s96(1A) Changes

Approved Section 96 (1A) (1) (2) Modification Application

No. MOD 1 granted on the 3 May 2018

Site 9, Sydney Olympic Park
3 Olympic Boulevard

Proximity to Rail Corridor Site Plan +
Building Envelope

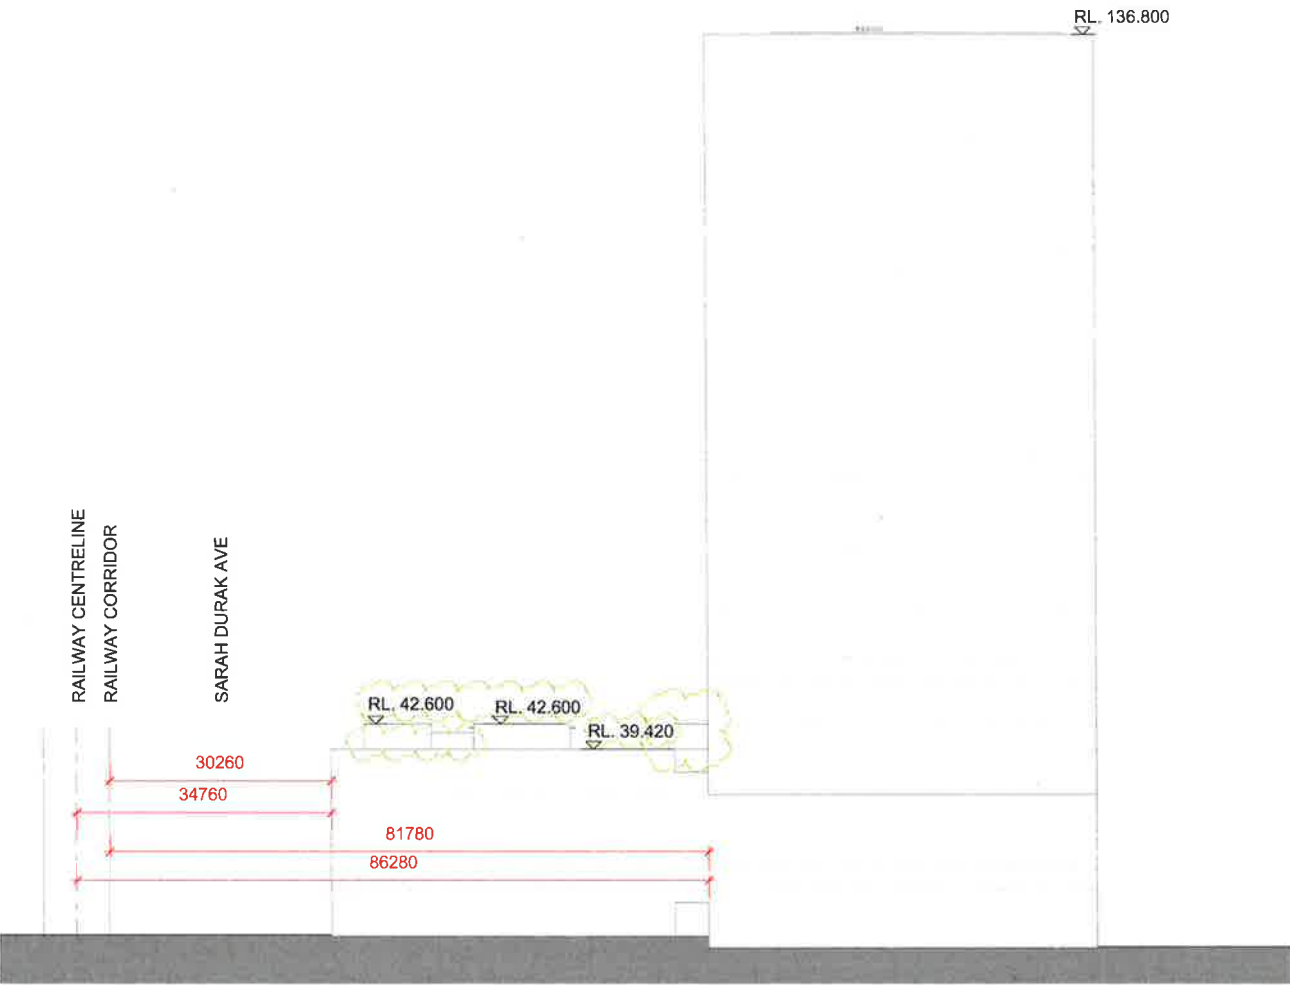
s96(1A) Changes

Pavilion, Atrium, and Parapet heights reduced to match Approved Elevation Heights

s96(1A) Changes

East Pavillion becomes a planter concealing services in void below landscape deck

Plant added to back of stair

General Arrangement Plan
Ground

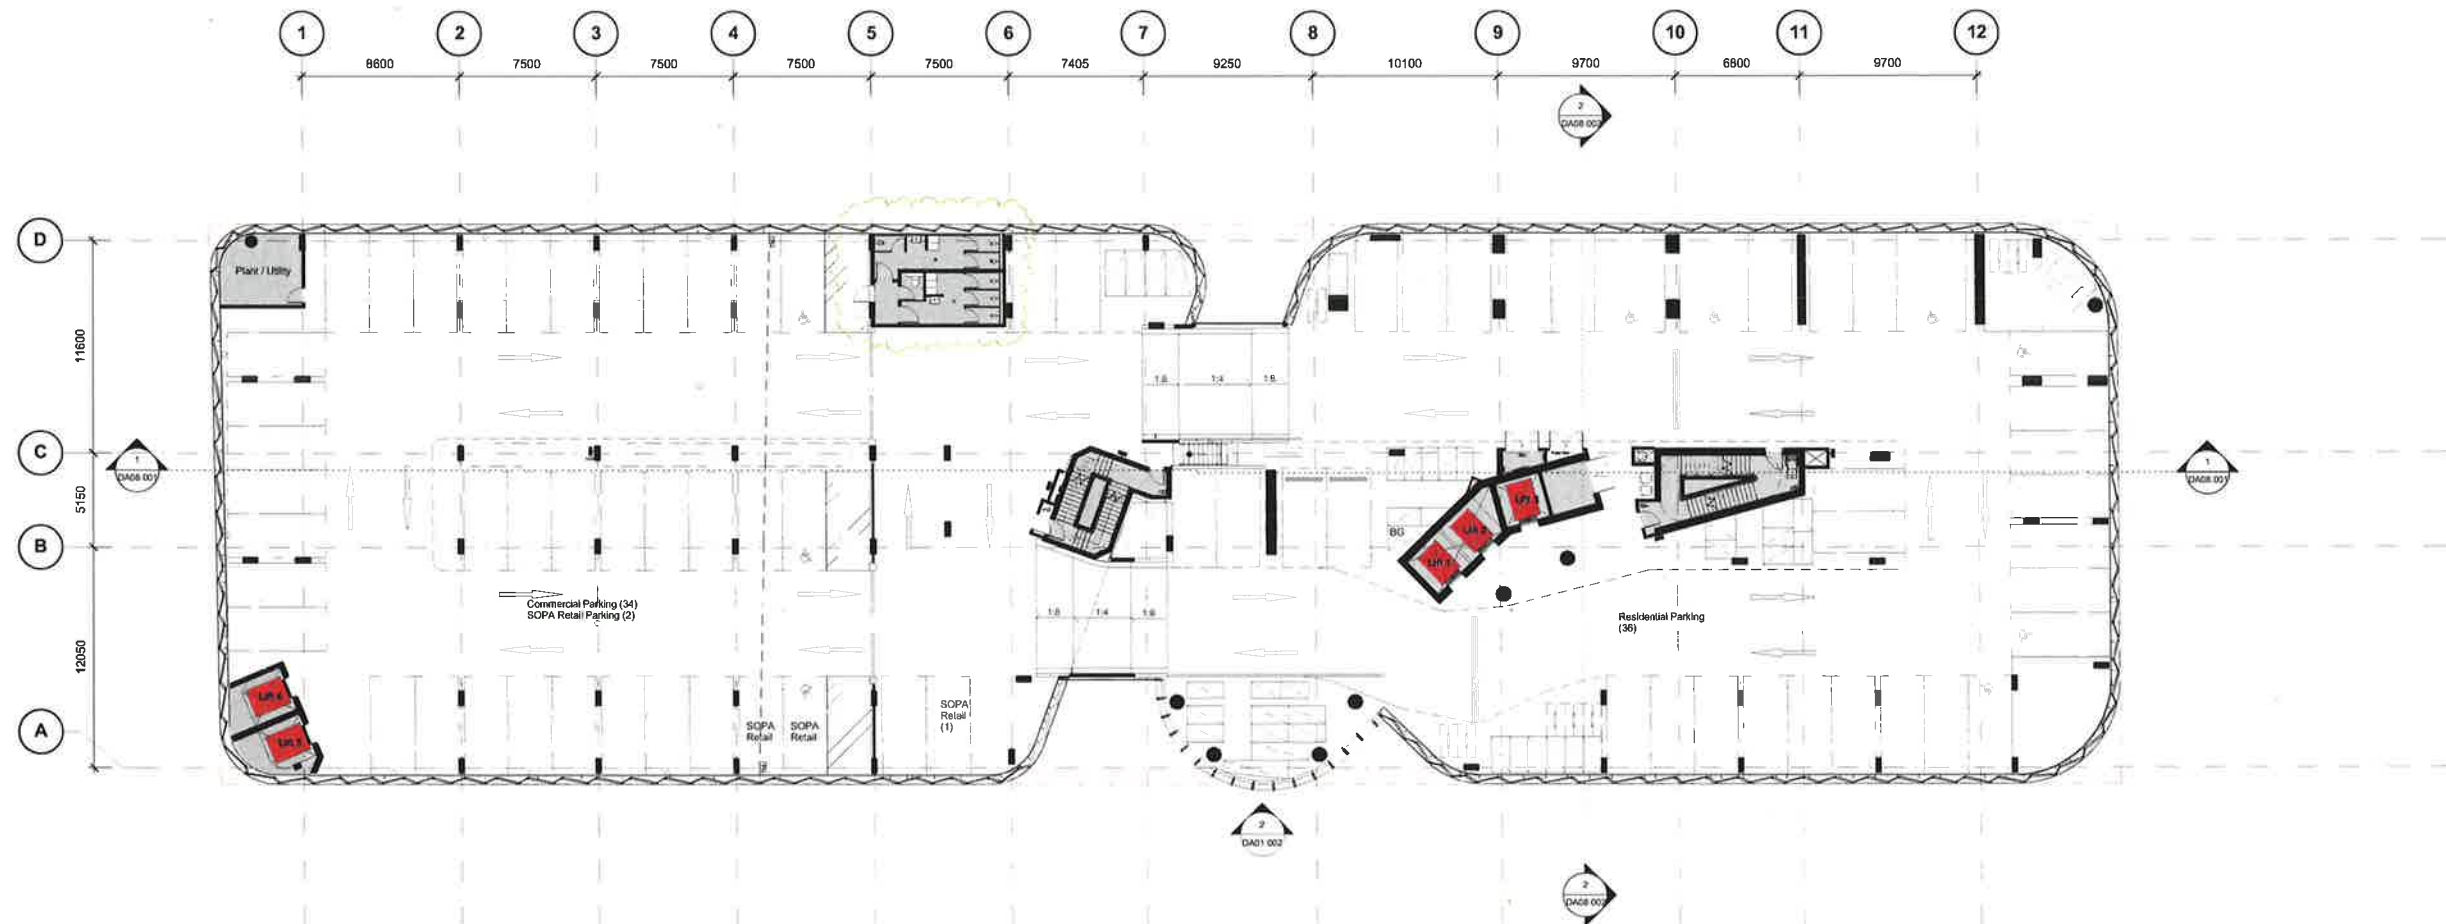
s96(1A) Changes

Modifications to plant areas

Minor adjustments to wall locations

Removal of Sub-Station Kiosk with enclosure of the facade to match streetscape elevation

Indicative locations of the non-loading bearing intertenancy walls, subject to confirmation

The proposed finish/material of the façade is indicative however is it expected to be a combination of glass (finish/material 3) and metal cladding/louvres (finish/material 10)

Roof Plan

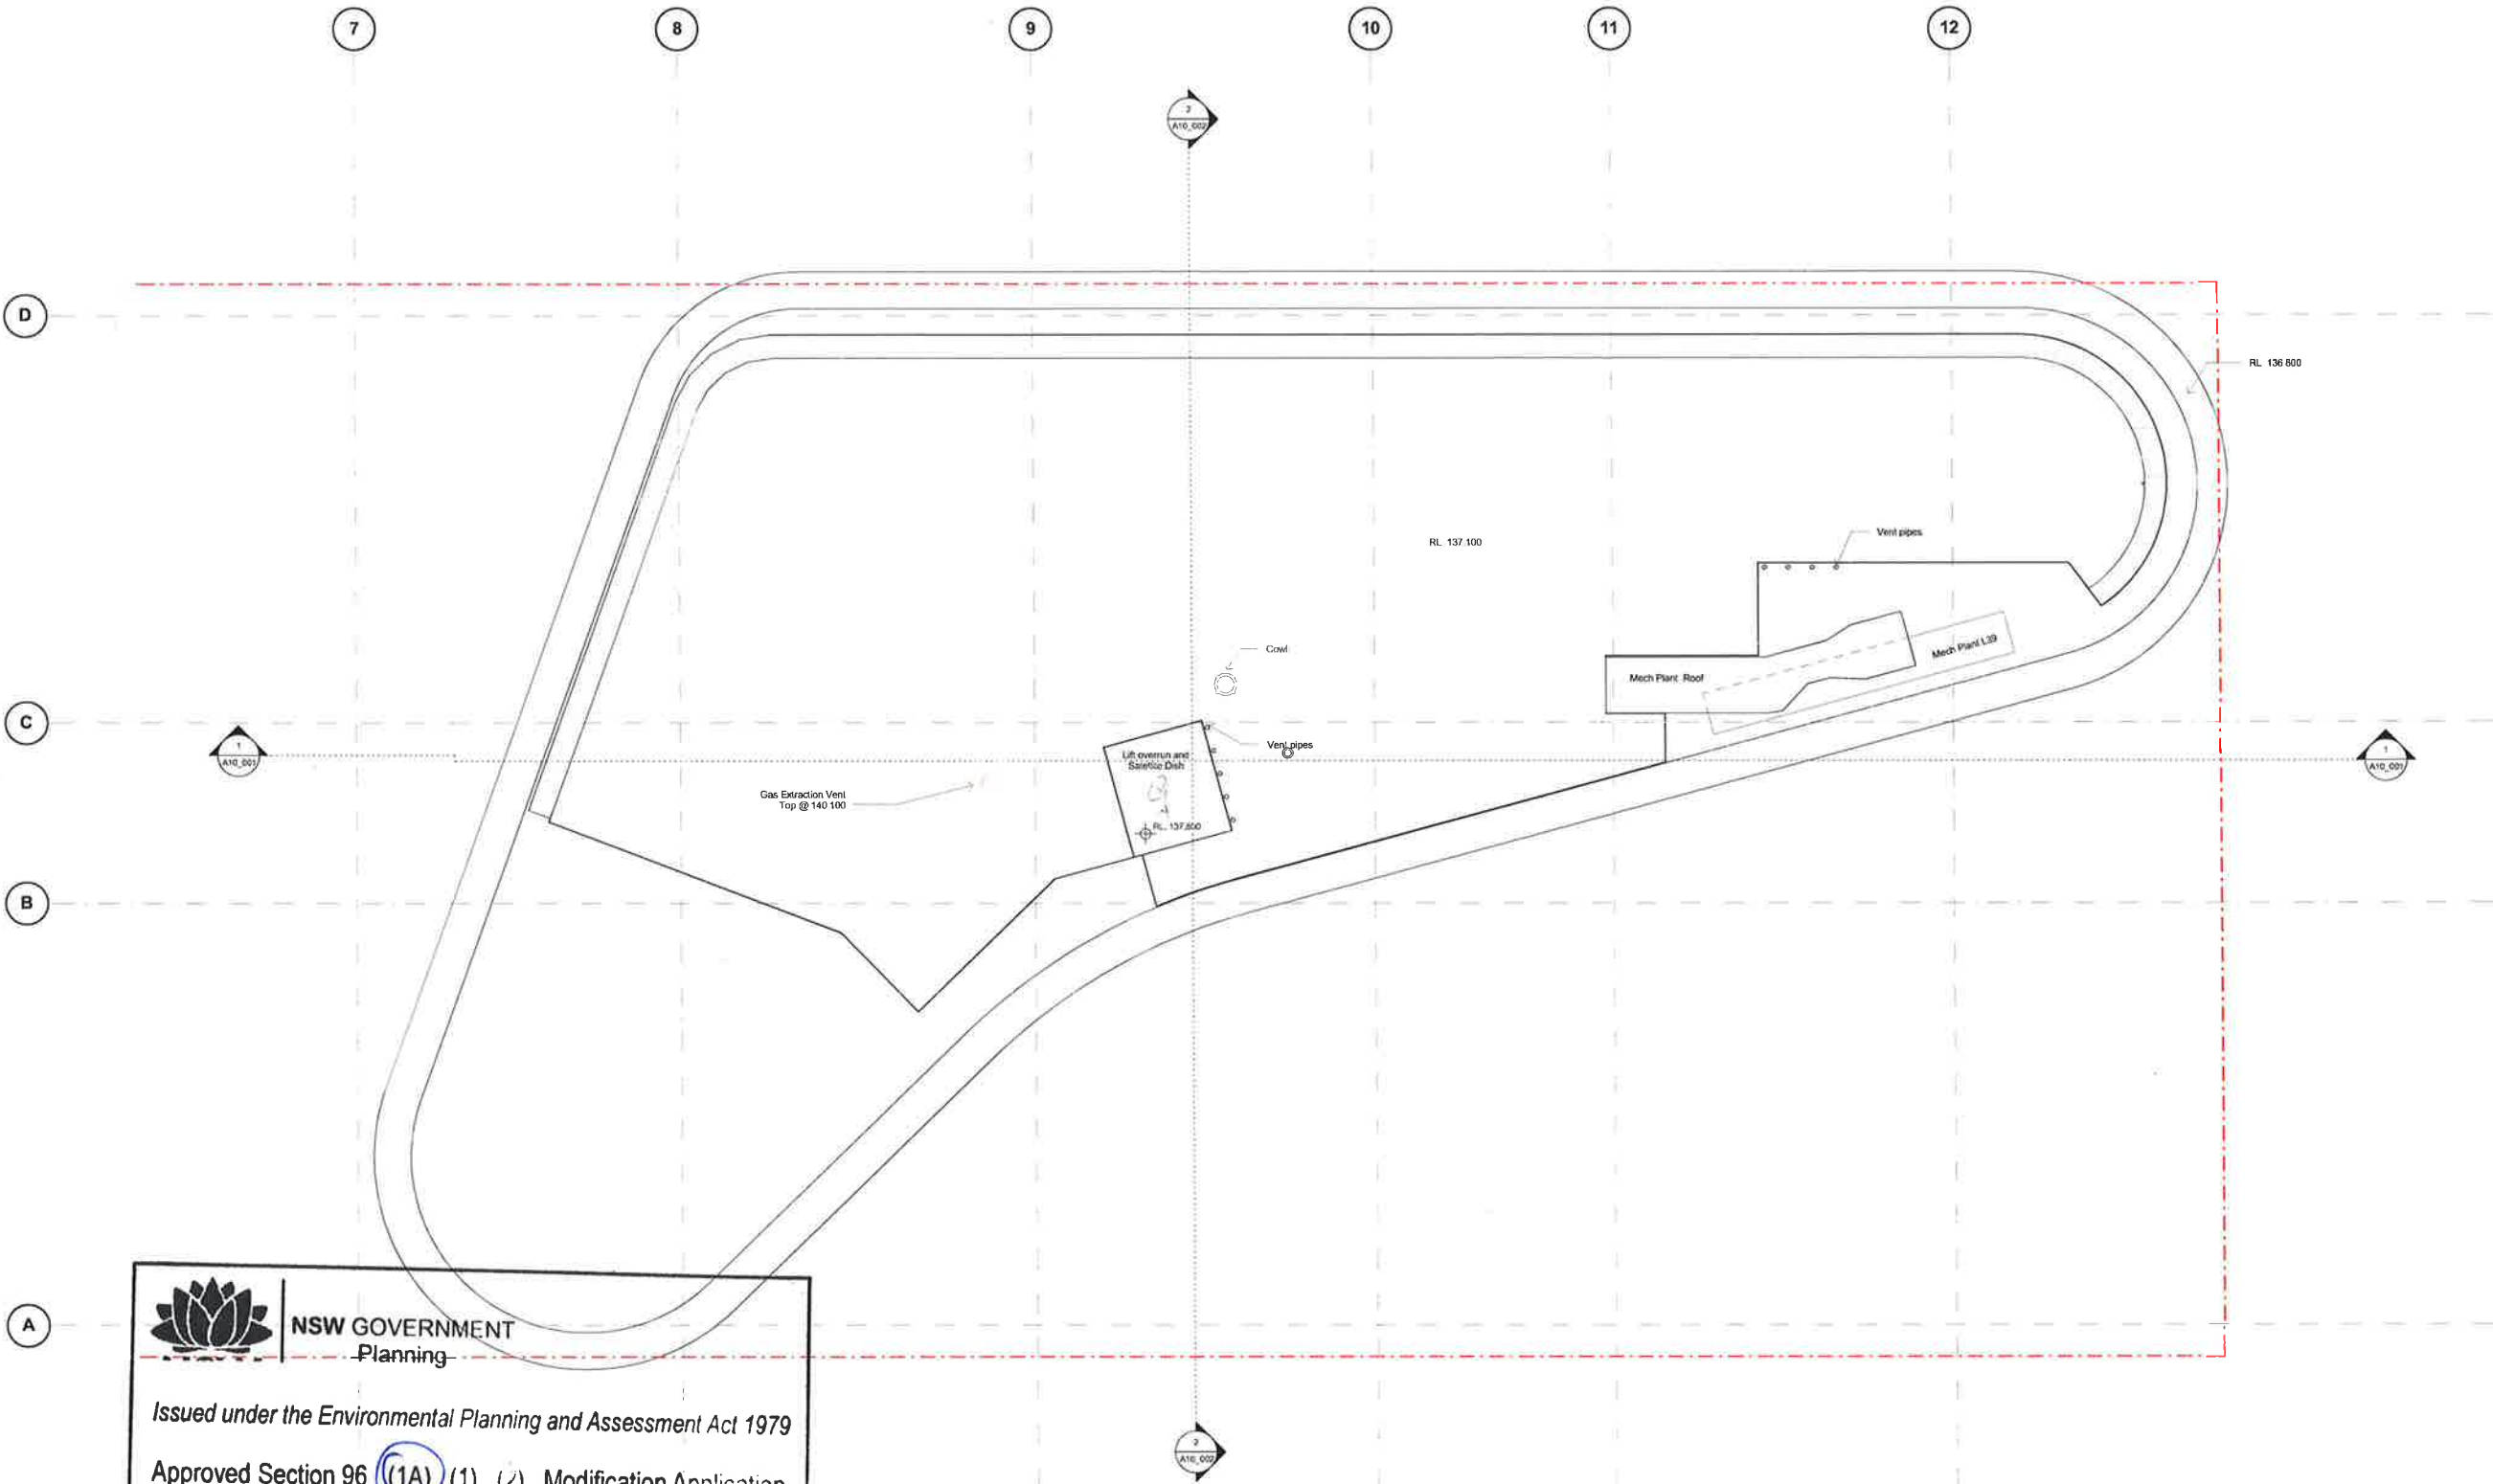
s96(1A) Changes

Services to roof including vent pipes,
mechanical equipment

Roof extension

Building Elevations
North East

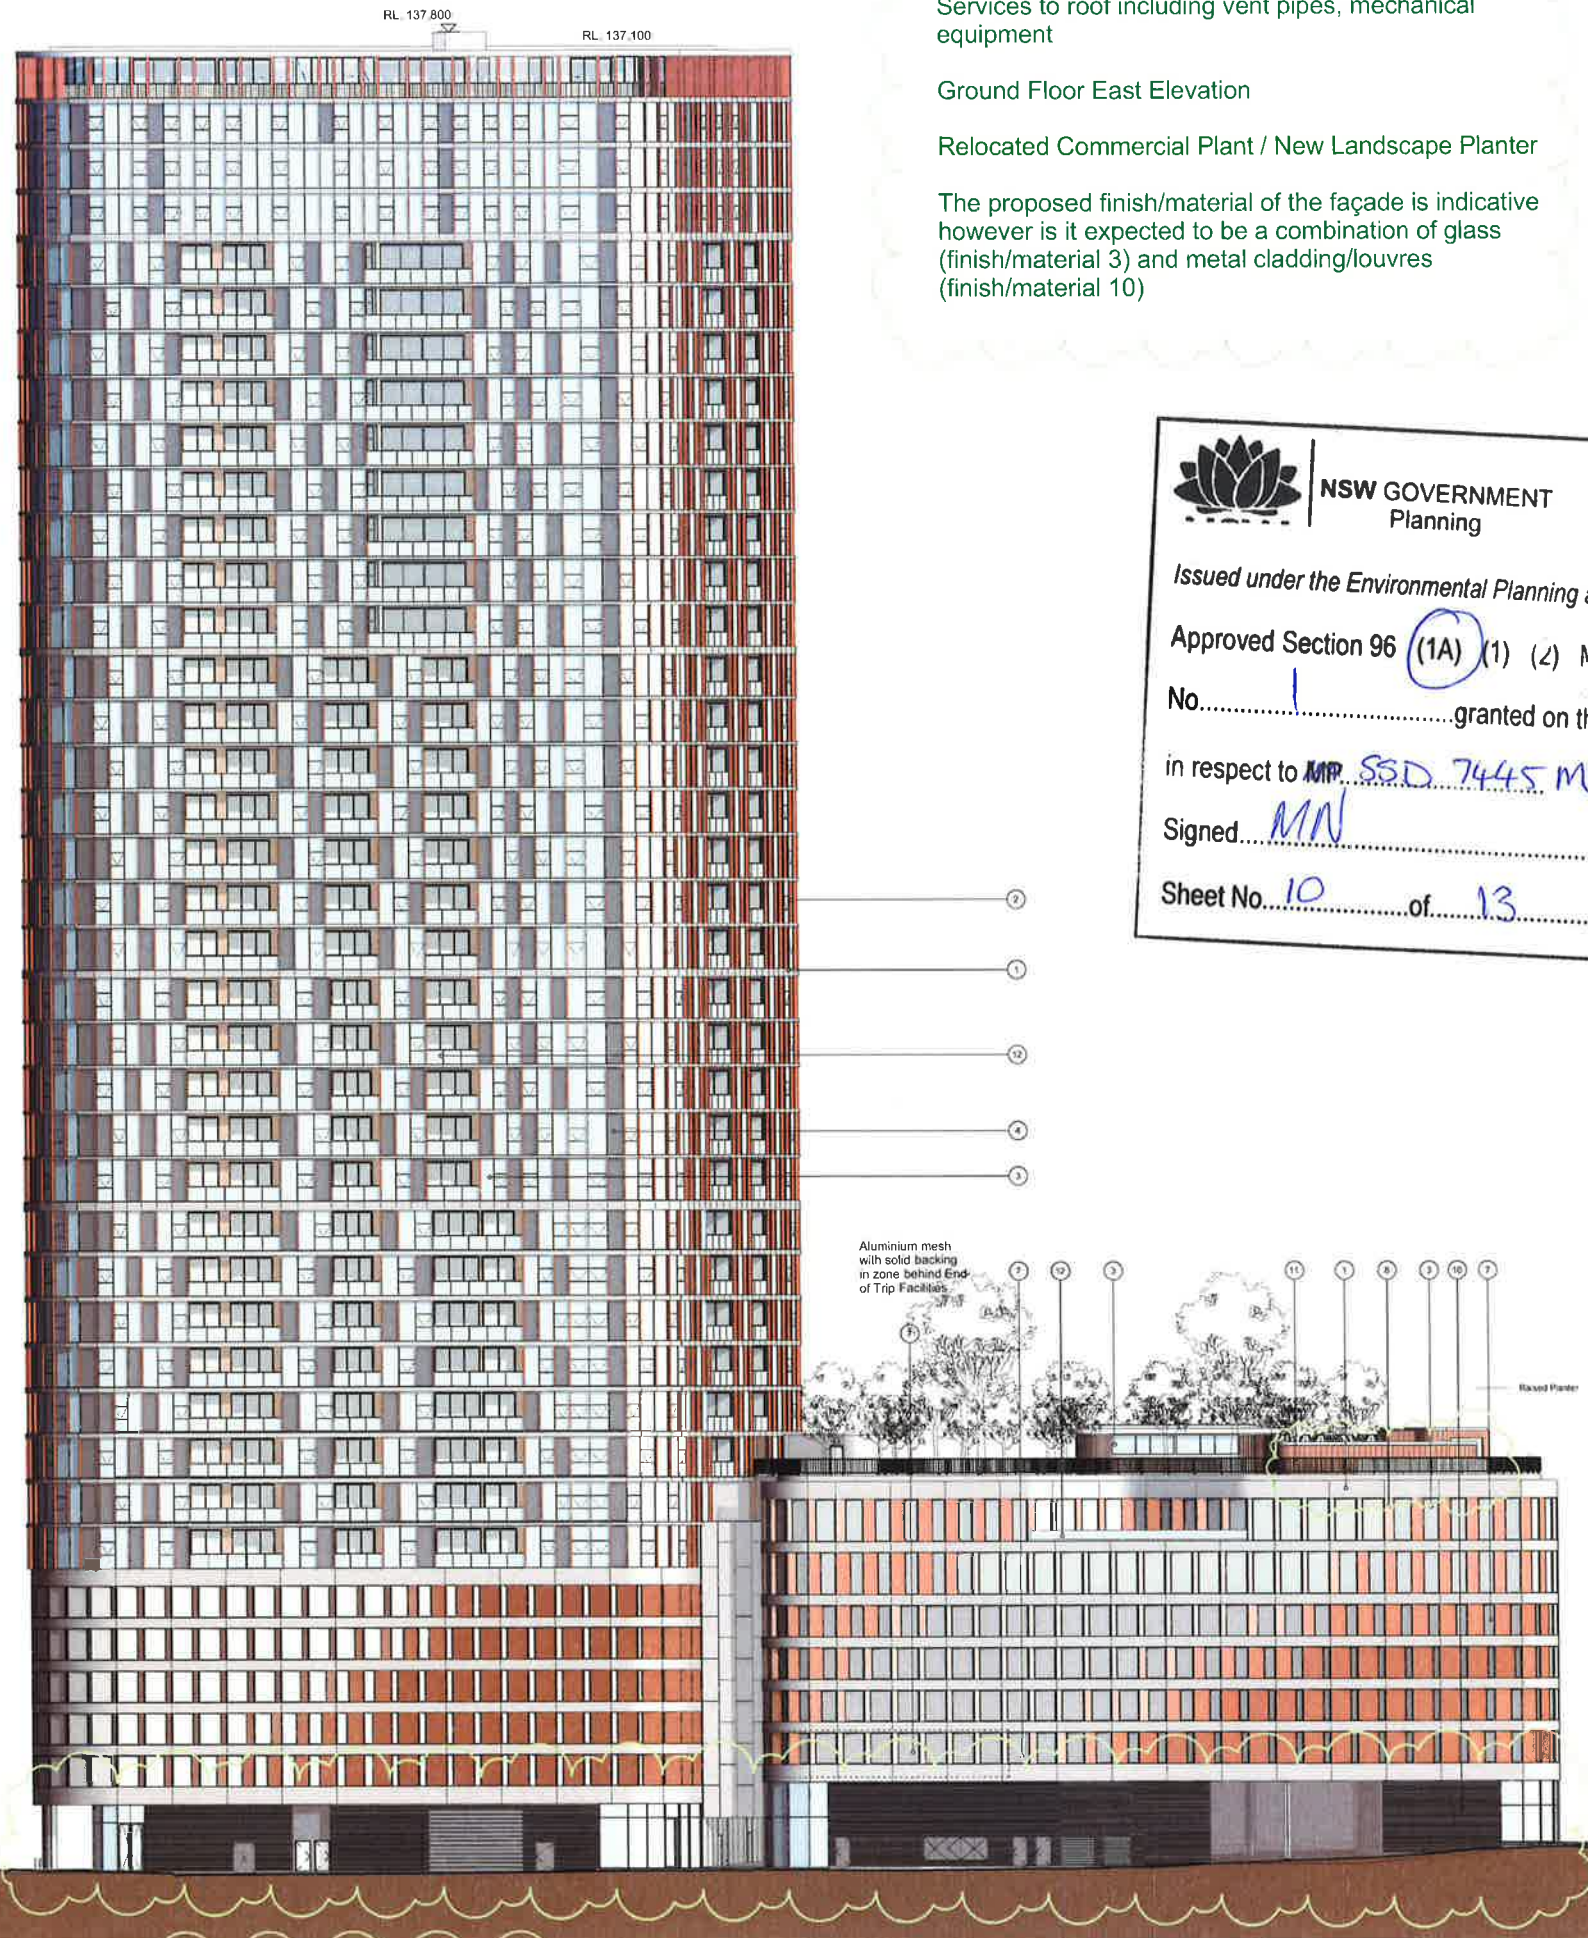
s96(1A) Changes

Services to roof including vent pipes, mechanical equipment

Ground Floor East Elevation

Relocated Commercial Plant / New Landscape Planter

The proposed finish/material of the façade is indicative however it is expected to be a combination of glass (finish/material 3) and metal cladding/louvers (finish/material 10)

Northwest

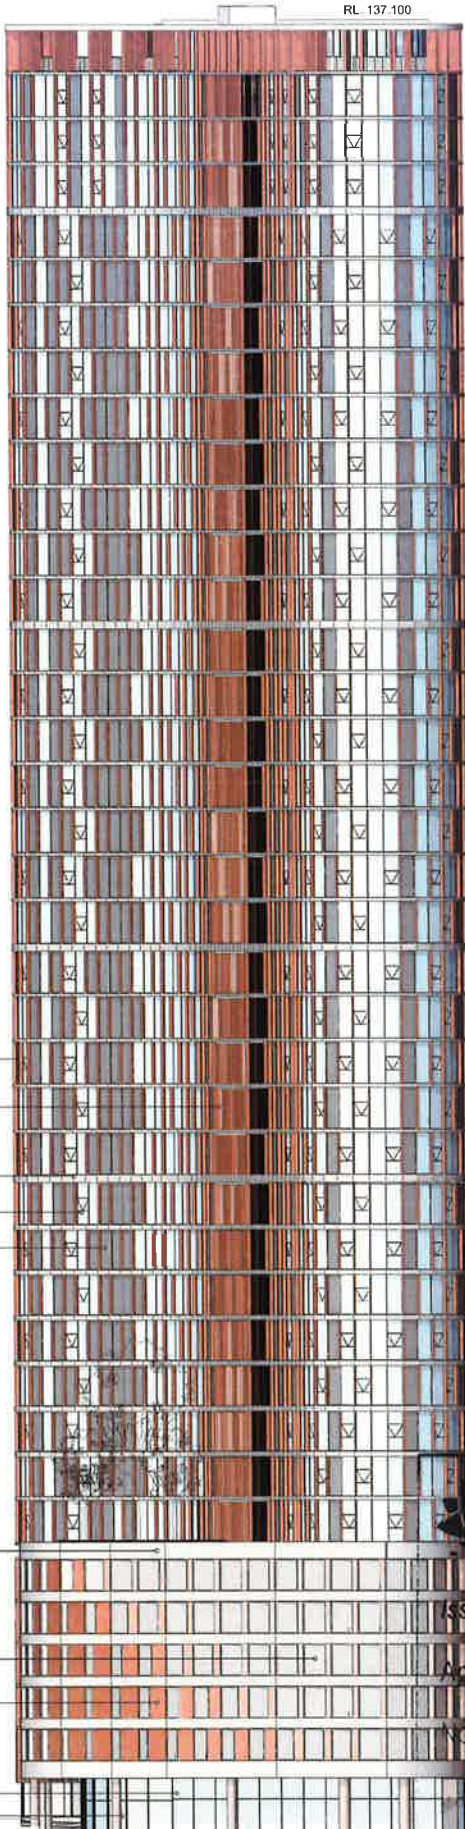
s96(1A) Changes

Services to roof including vent pipes, mechanical equipment

Relocated Commercial Plant / New Landscape Planter
